Tech Note

Temporary Substitute for BEP 770-EZ Mount On/Off Switch

Published 8/17/2026

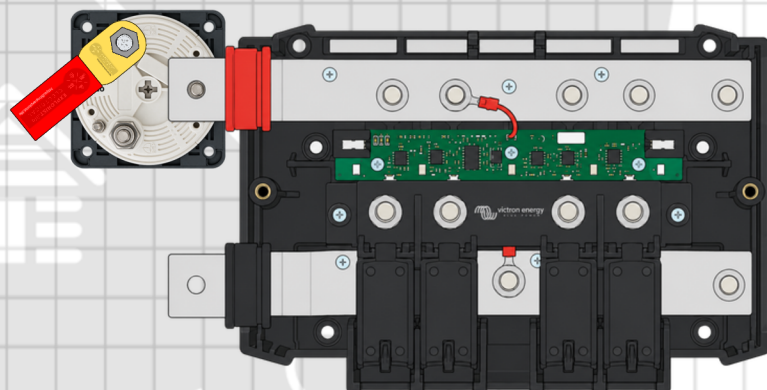
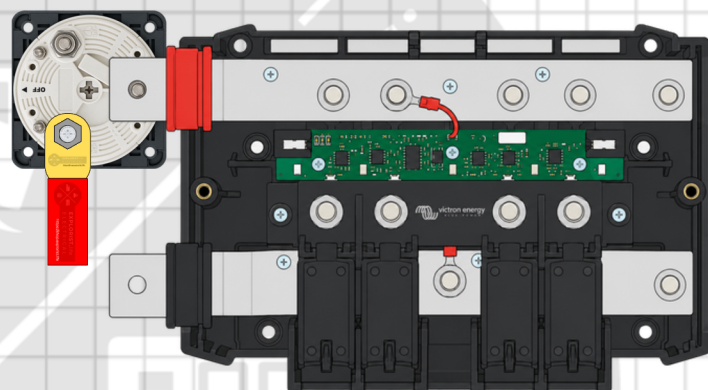
A nationwide shortage of the BEP 770-EZ has required us to substitute the BEP 771-S-EZ (pictured right) as the next-best available option.

The only functional difference between the two switches is that the BEP 771-S-EZ has two input studs (left two center studs) and one output stud (right center stud).

Install the BEP 771-S-EZ in the same manner as the BEP 770-EZ Mount On/Off Switch.

The battery input cable may be connected to either of the two input studs.

For normal operation, use either:

- "1 & 2" - Allows power to flow from both input studs. Recommended.
- "1" **or** "2" - Selects only the corresponding numbered input stud.
-

For most installations, we recommend leaving the switch in the I & II position.
